Reference: 20210067-L04_response letter_RFI.docx

**RE: DELMAR PARADE, DEE WHY – DA2022/0145
REQUEST FOR FURTHER INFORMATION (FLOODING)**

Further to Council's referral response on flooding and our meeting to discuss the comments raised by Council, we provide our responses in **GREEN** to the flooding comments.

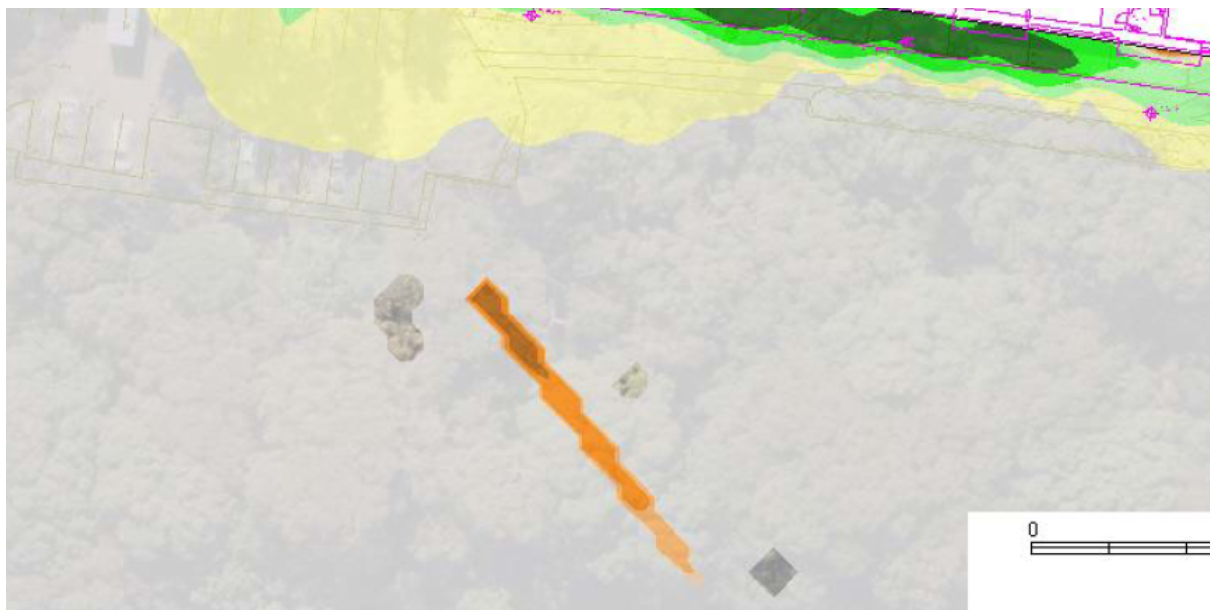
Irrespective of this, it is clear from the results provided, that by collecting and conveying the entire overland flow to a single discharge point in Delmar Parade has exacerbated existing flood behaviour at various locations, e.g flood depths increased by at least 0.1m and velocity x depth now has increased to above 0.4 etc See figures below. This resulted in increased flood risks to existing properties and road users in Delmar Parade, Accordingly, does not comply with item A1 of section B3.11 of DCP.

- *Submit sufficient information in quantity and clarity that will enable accurate, detailed assessment of the likely flood impacts to upstream, neighbouring and downstream properties.*

It is suggested that flood maps should show information on the differences between pre and post development conditions for a range of flood behaviour characteristics, including life hazards parameters etc.

With regard to the increase in flood levels caused by the proposed trunk main upgrade and as per our meeting with council, we note that the increase is caused by the surcharge from the infrastructure at the connecting pit between the upgraded trunk main through the site and the existing 900mm DIA pipe under Delmar Parade.

The afflux caused by the surcharge is evident on the flood impact map (scenario s3), extract of which is shown below.

This afflux is understandable and expected because the proposed infrastructure through the site can carry much more water than the existing 900mm DIA pipe. The modelling shows that the proposed trunk main which is increased from 1050mm DIA to 1200mm DIA at the high end of the site and to 1350mm DIA at the lower end of the site is carrying 4.8cums which is reduced to 1.8cums in the existing downstream trunk main under Delmar Pde. This causes a surcharge at the junction pit which is localised on top of the pit in the road and does not impact private properties.

Fig A2.15 extracted from the flood study report shows the levels impact upstream and downstream of the site. As previously explained and demonstrated, the increase in levels beyond the accepted

values are confined to a localised section in Delmar Pde downstream of the site, otherwise a significant reduction in flood water is expected in all other areas.

Upstream of the site, there is an afflux inside the open gully in the reserve which is confined to the gully itself and does not spill onto the reserve and anywhere else. This is also a confined spill that has no adverse impacts elsewhere in the floodplain. Extract from Fig A2.15 showing the upstream afflux in the open gully is included below.
